UNITED STATES PATENT AND TRADEMARK OFFICE

APPLICATION NO.	FILING DATE	FIRST NAMED INVENTOR	ATTORNEY DOCKET NO.	CONFIRMATION NO.
09/585,472	06/02/2000	Michiaki Sakamoto	157330/99	6609
21254	7590	02/10/2005	EXAMINER	
MCGINN & GIBB, PLLC 8321 OLD COURTHOUSE ROAD SUITE 200 VIENNA, VA 22182-3817			RUDE, TIMOTHY L	
			ART UNIT	PAPER NUMBER
			2883

Office Action Summary

DETAILED ACTION

FIG. 3

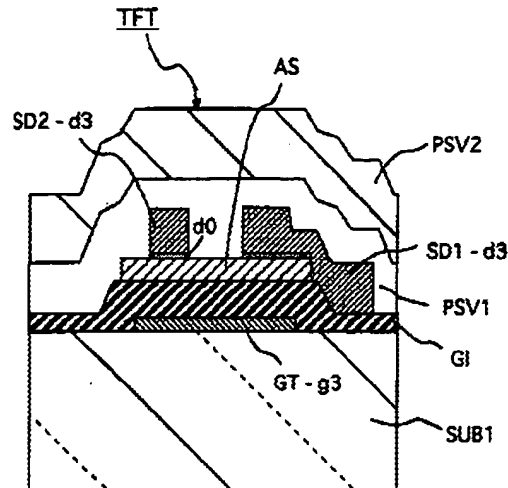
Ohta teaches the use of a passivation film exclusively over and in direct physical contact with the TFT portions to protect a back channel portion of the TFT and thereby stabilize a threshold voltage, V_{th} (col. 8, lines 34-67) without warping of the substrate caused by the stress of said passivation layer. Please note that modification of the device of Zhong with the passivation film of Ohta would result in said passivation film and said color film form a stack of layers that reduces a thickness of material of said color filter near said contact hole such that a portion of said passivation film remains in place adjacent to said contact hole.

Ohta is evidence that ordinary workers in the art of liquid crystals would find the reason, suggestion, or motivation to add a passivation film exclusively over and in direct physical contact with the TFT portions wherein said passivation film and a color film form a stack of layers that reduces a thickness of material of the color filter near said contact hole such that a portion of said passivation film remains in place adjacent to said contact hole to protect a back channel portion of the TFT and thereby stabilize a threshold voltage, V_{th} , without warping of the substrate caused by the stress of said passivation layer.

Therefore, it would have been obvious to one having ordinary skill in the art of liquid crystals at the time the invention was made to modify the LCD of Zhong with the passivation film exclusively over and in direct physical contact with the TFT portions of Ohta wherein said passivation film and a color film form a stack of layers that reduces a
